GROUP 26

FRONT AXLE

OUTLINE OF CHANGE

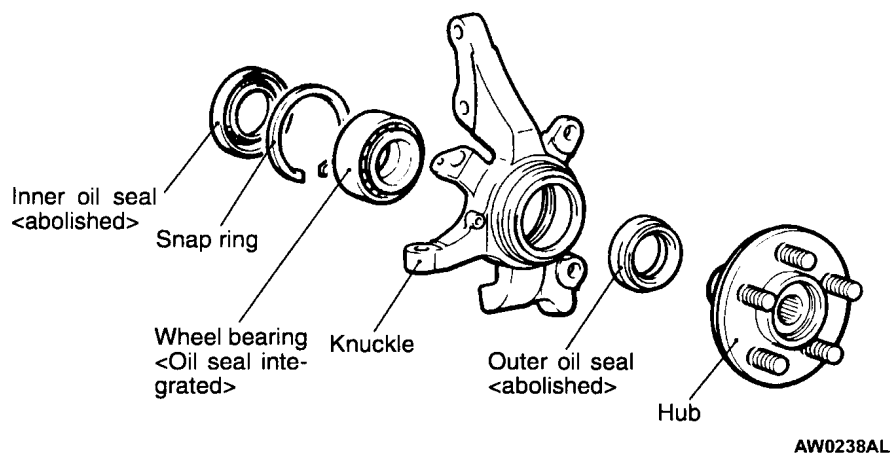
- The front differential reduction gear ratio has been changed due to the introduction of 2000-mL engine.
- The service procedure has been changed since the wheel bearing has been changed from the previous oil seal separate type to the integrated type.

Item		New	Old
Reduction ratio		4.636* ¹ , 4.900* ²	4.875
Number of teeth	Drive gear	51* ¹ , 49* ²	39
	Drive pinion	11* ¹ , 10* ²	8

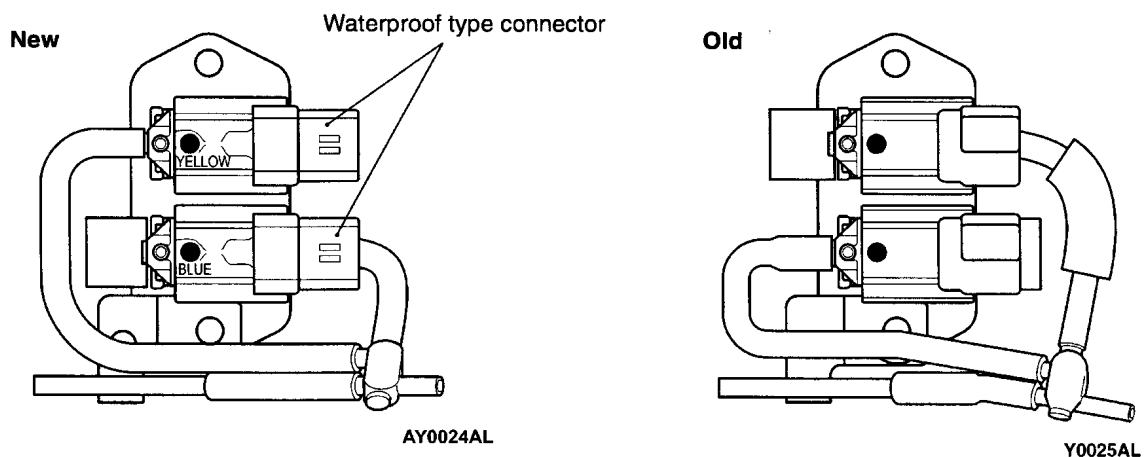
- The solenoid valve for the free-wheeling mechanism has been changed.

BW0238AL

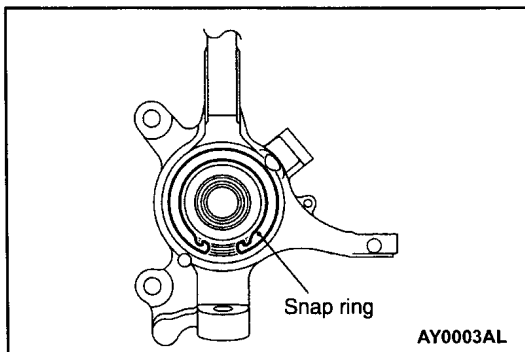
- ▶D◀ • Hub rotation starting torque check
 ▶C◀ • Wheel bearing axial play check
 ◀A▶ 1. Hub
 ▶B◀ 2. Snap ring

- ◀B▶ ▶A◀ 3. Wheel bearing
 4. Knuckle

Only the service procedure below has been added. The other service procedures are the same as before.

▶B◀ SNAP RING INSTALLATION

The notch in the snap ring should face down.

The sealing performance between the snap ring and the bearing seal can be ensured by making the snap ring face down. If the snap ring notches face toward the different direction, the sealing performance may be impaired.
